**FINAL DESIGN CONCEPT REPORT
SR-24, Ellsworth Road to Ironwood Drive
Interim Phase II**

**TRACS No. 024 MA 001 H8915 01L/02L
Federal Project No. STP-024-A(200)T**

**PREPARED BY:
Parsons Transportation Group, Inc.
222 S. Mill Ave, Suite 220
Phoenix, AZ 85281**

January 31, 2017

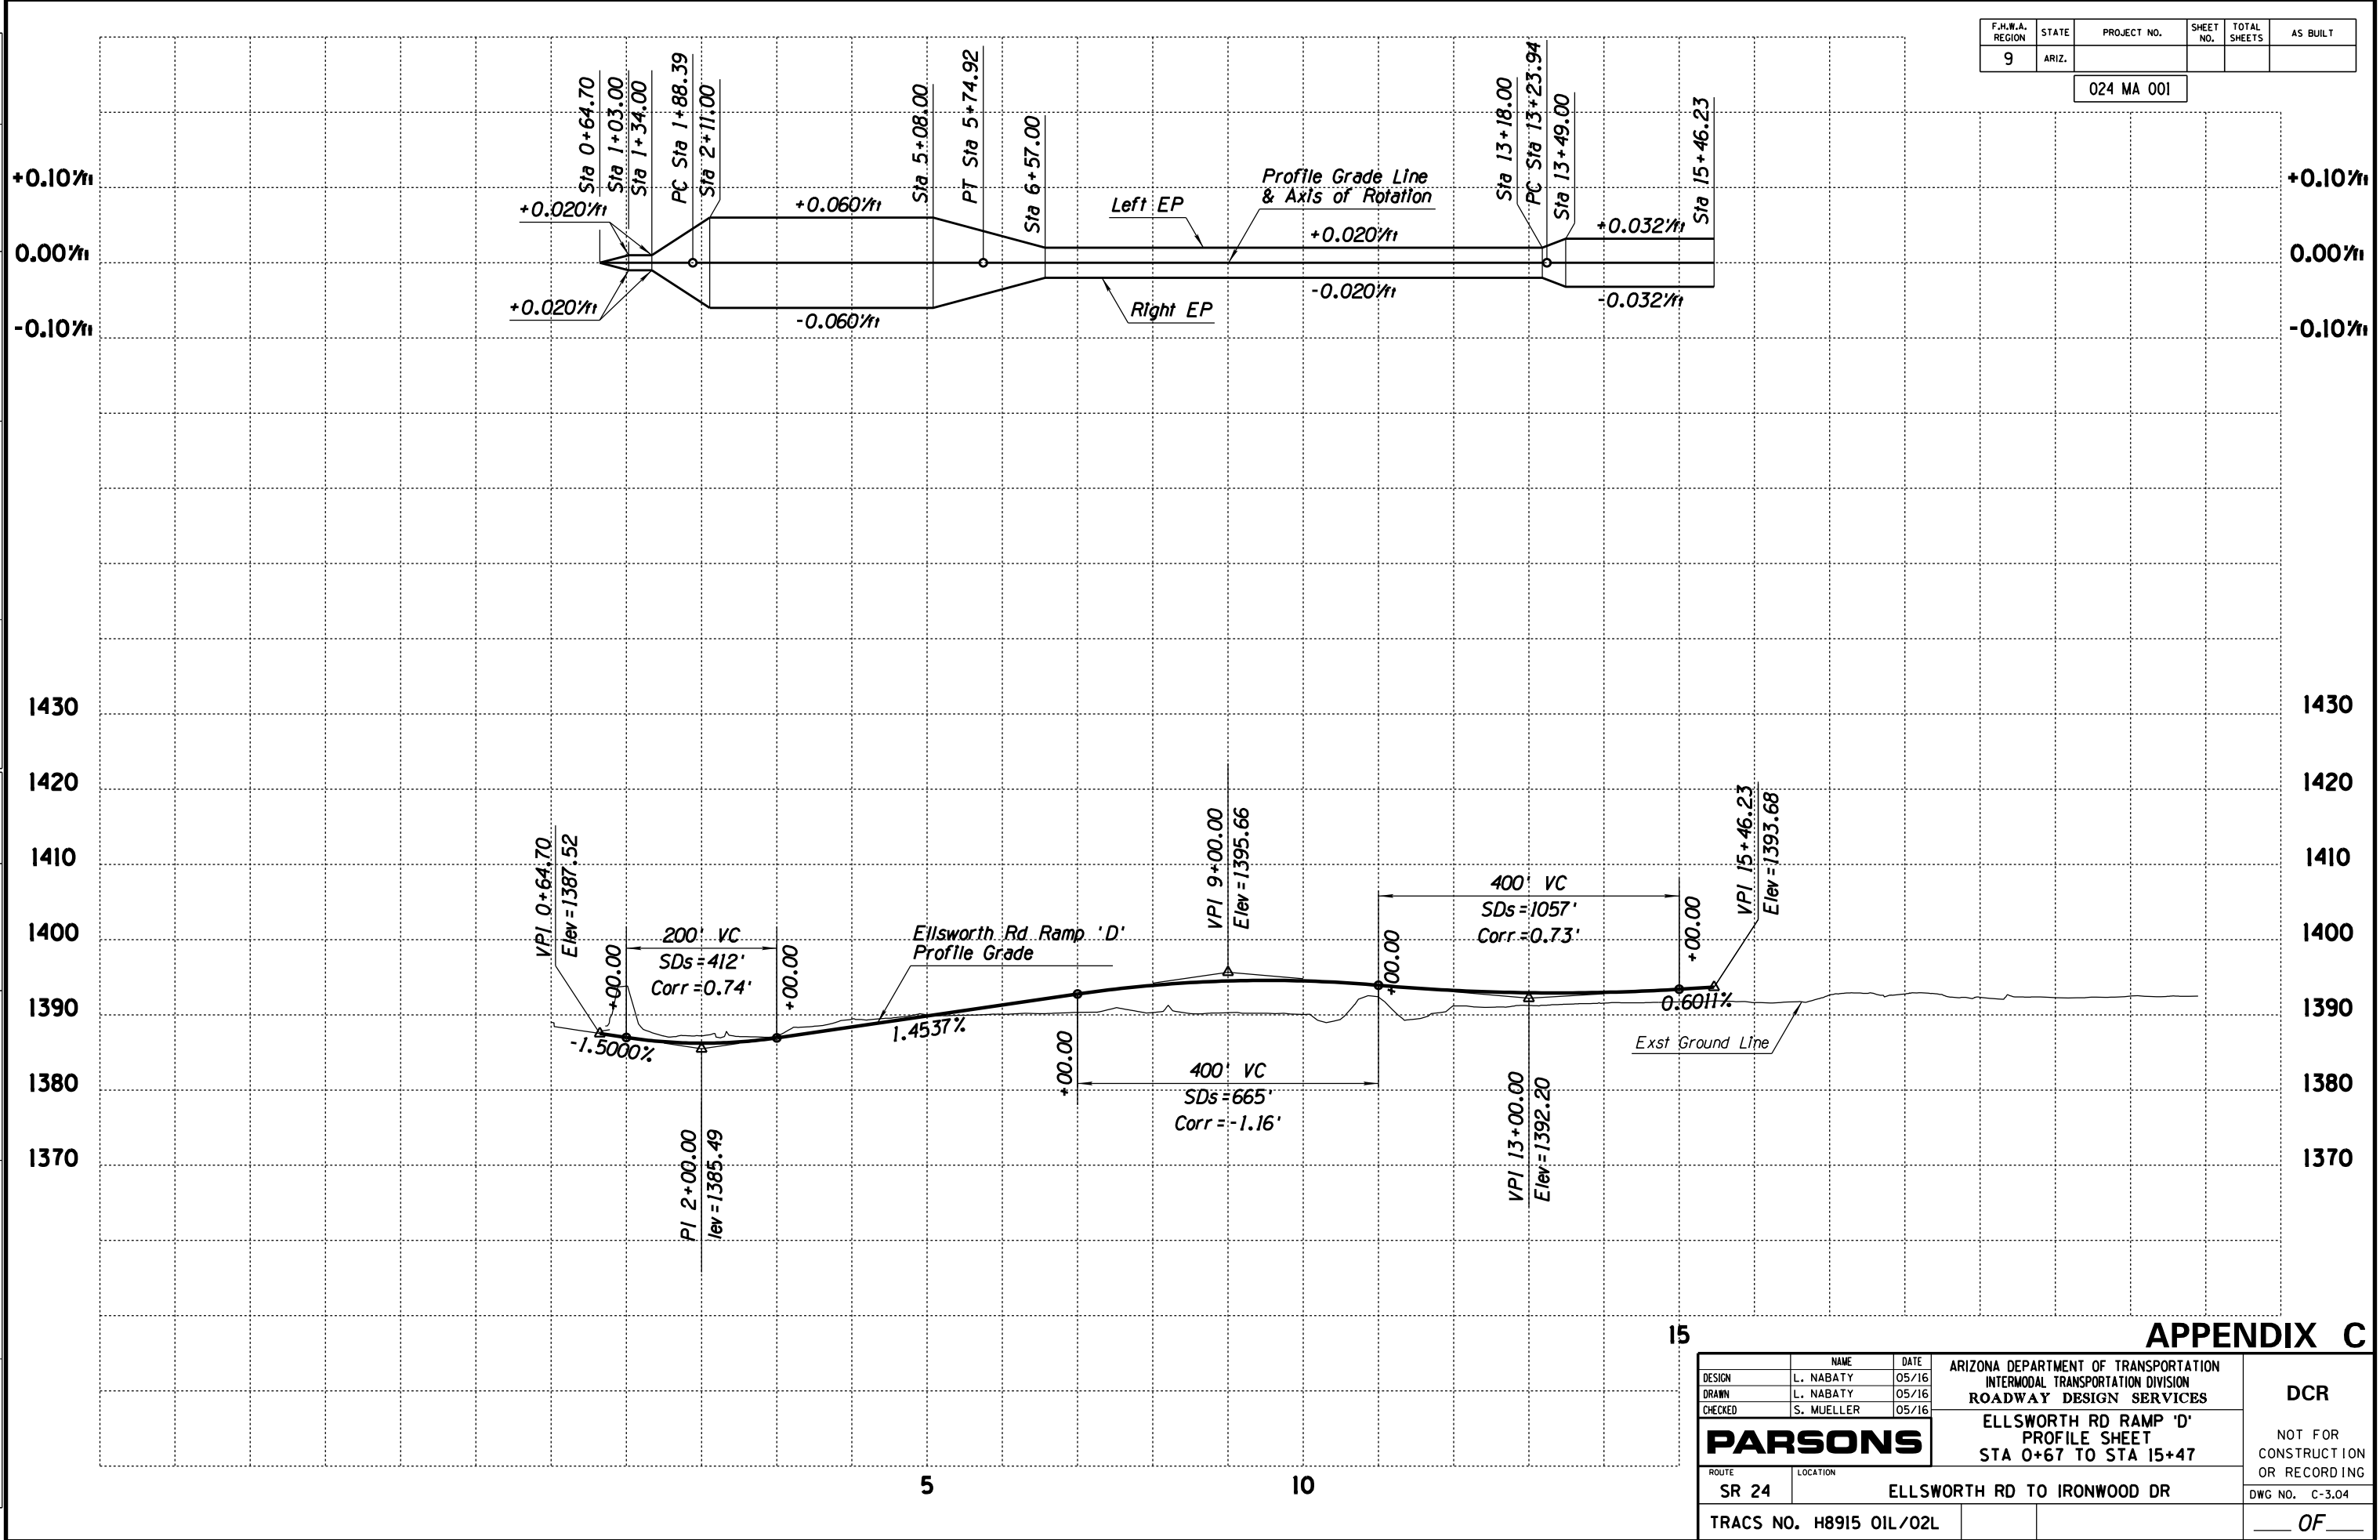
104	7	C-3.05	Based on plans data there may be an excessive grade difference across the gore nose at Ellsworth Ramp D. Please check.	B	A	Profile to be revised.
105	8	C-3.07	Recommend acquisition of access control per ADOT RDG Fig 506A on both ends of Williams Field.	B	A	Discussion has occurred on this subject with ADOT R/W. Some development planning has occurred based on the pre-2014 RDG Access Control Requirements. We will show Access Control (Full & Right in Right Out per the RDG Fig 506A
106	9	C-3.09 & C-03.10	Beginning profile grade seems to be missing for Ramps A & B.	A	A	Will add
107	10	C-3.11	Ramp terminus station seems to be at odds with callouts on Sht C-3.13. Please check.	A	A	Will revise

Figure 6: 2025 Option A - Proposed Lane Configurations and Stop Controls

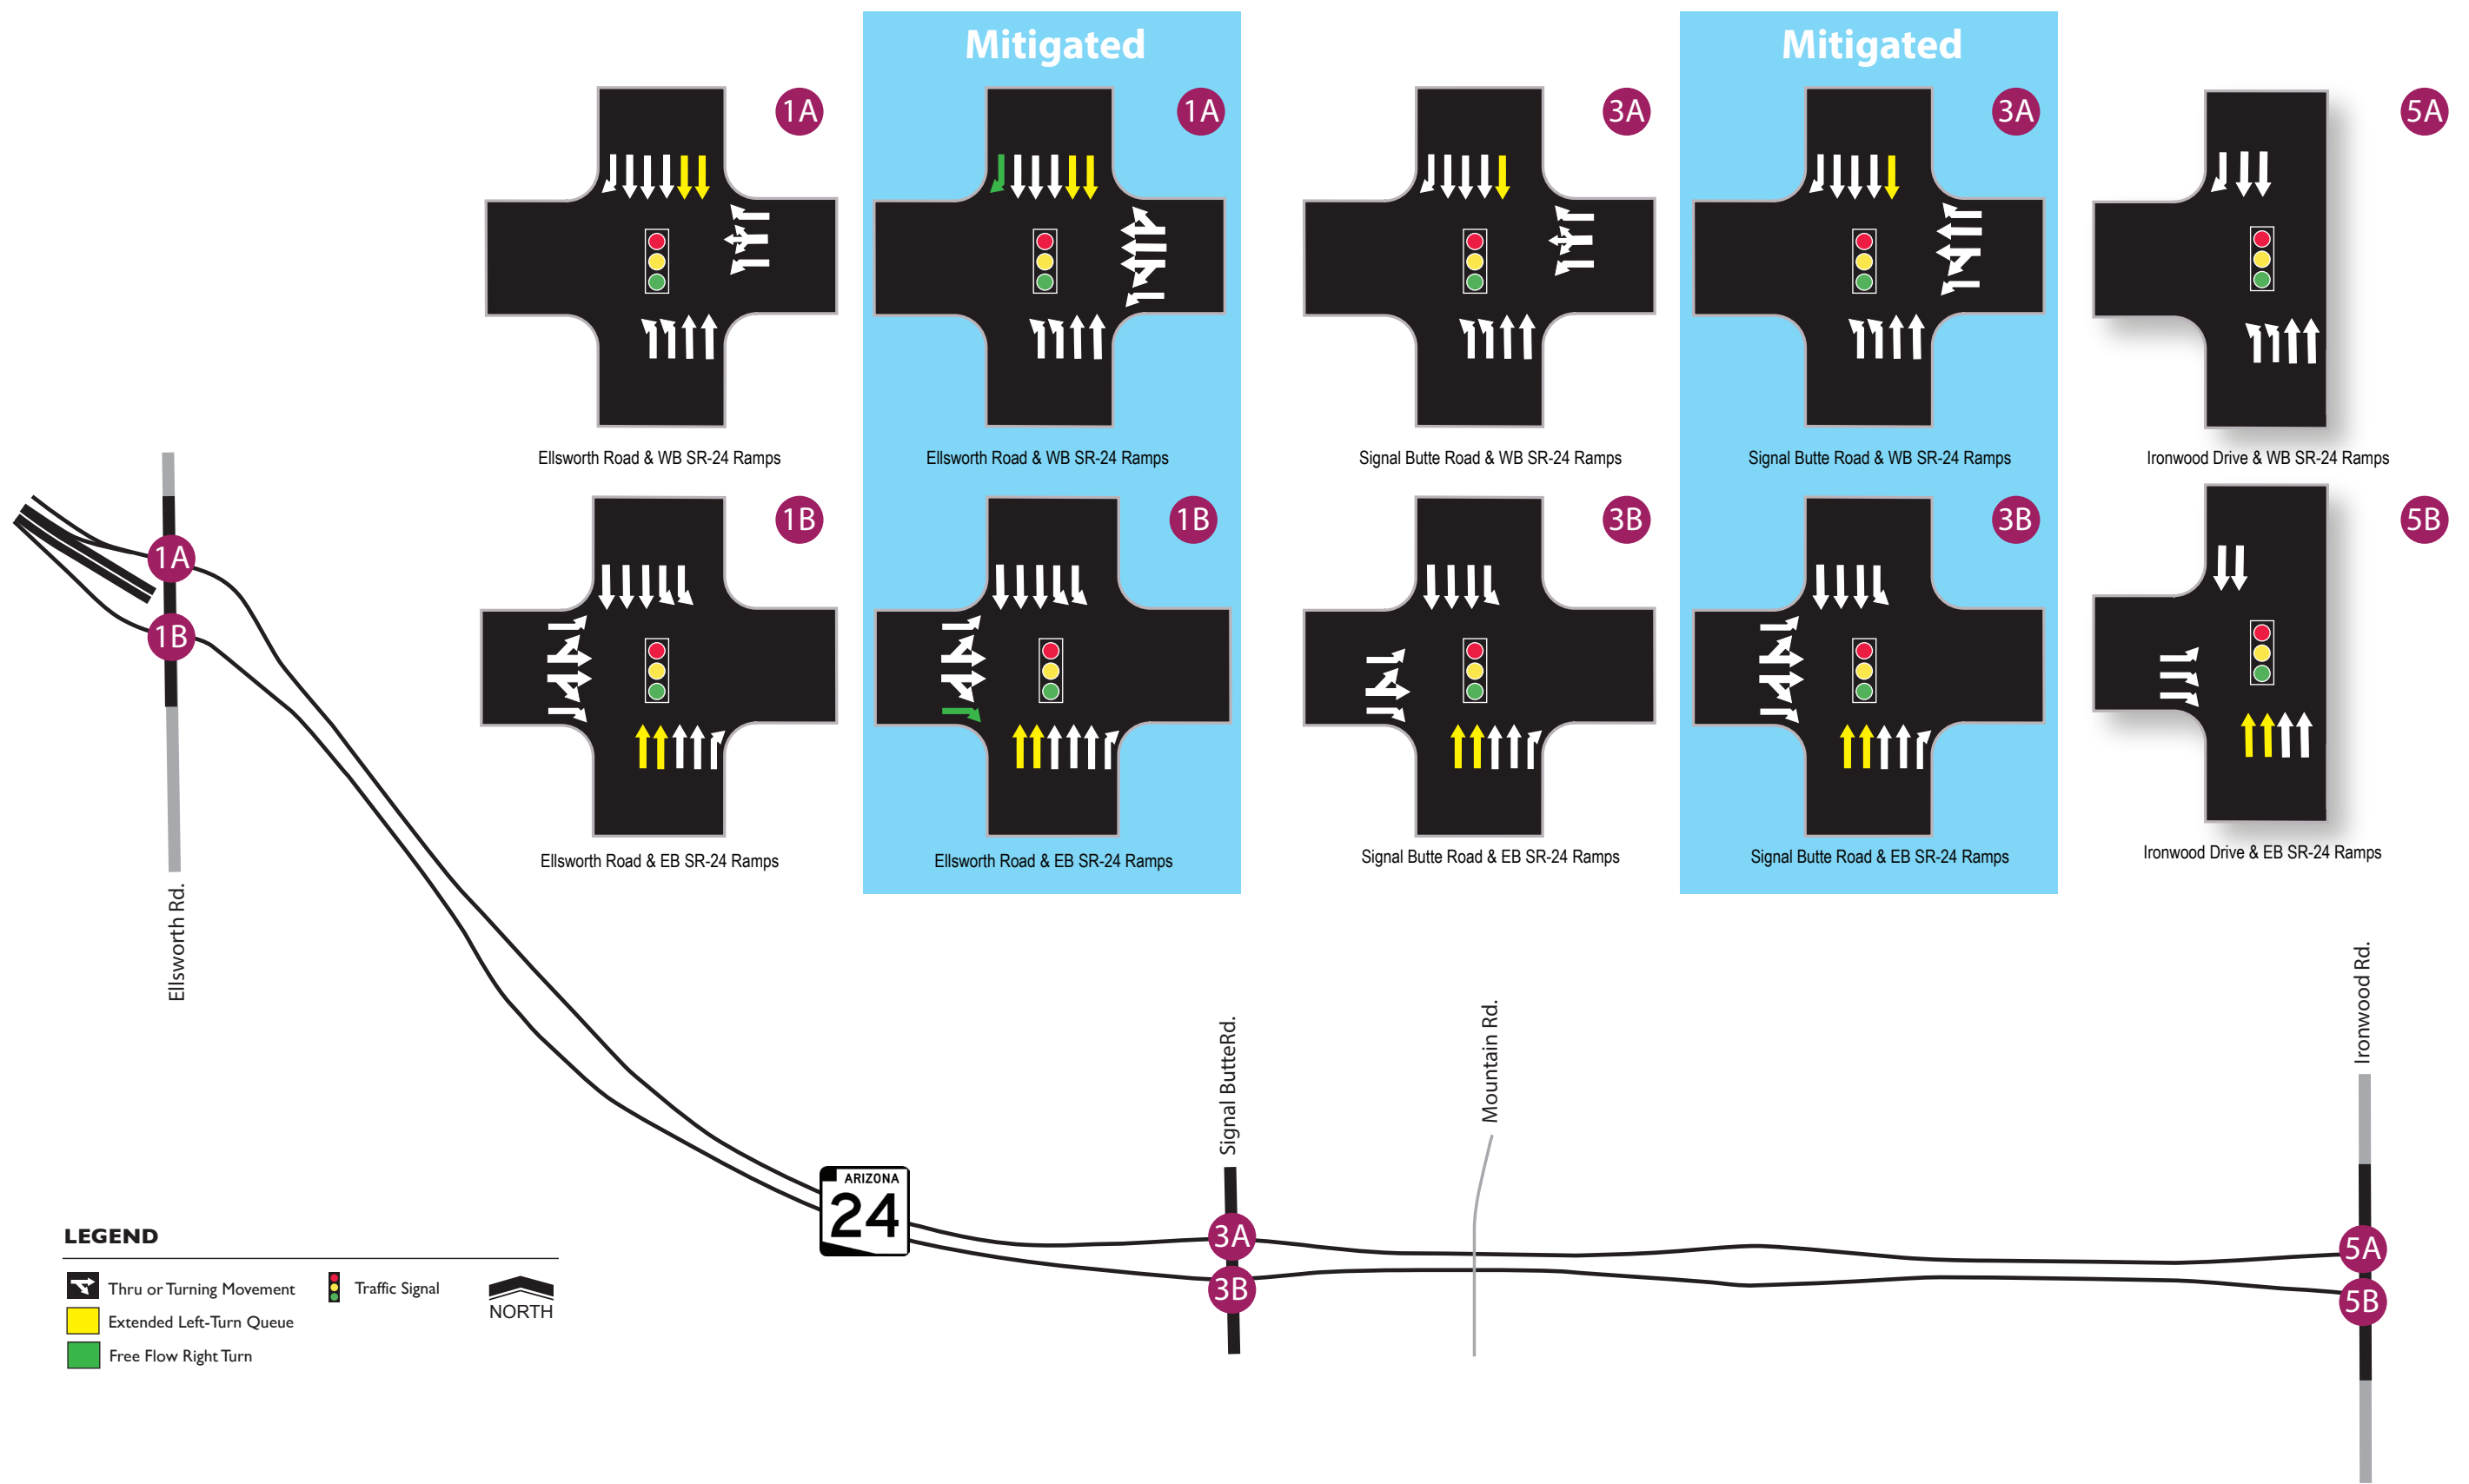
OVERALL COMMENT NO.	REVIEWER COMMENT NO.	DWG, SHT, PAGE NO.	COMMENT	INITIAL CODE	FINAL CODE	DESIGNER RESPONSE
26	20	Traffic Analysis Report	On Page 18, 20, Figure 6, and Figure 7 for the Mitigated intersections, adding a third left turn lane for the WB on ramp at Ellsworth would improve the level of service for Option A and Option B but there are other factors that also need to be considered. By adding the third left turn lane this would mean widening Ellsworth Rd with another lane on top of the third NB through lane. Also, the WB on-ramp would need to be widened to three lanes from the existing two in order to accommodate the third left turn lane. By adding the third lane on the ramp there would need to be enough room in order to merge that third lane prior to Ramp A or leaving the third lane as the Ramp A lane from the Ellsworth intersection.	B	A	The project team will evaluate the recommended intersection geometry at the intersection of Ellsworth Road and SR 24 WB Ramp due to the impact to the SR 24 EB on ramps and Ellsworth Road. Pavement widening on Ellsworth Road is to accommodate the 12-foot lane shift of the existing NB through lanes. The additional pavement width will be used for the third northbound left turn lane. Ellsworth Road will not be widened to three through lanes. The WB on ramp would need to be widened to add an additional lane.
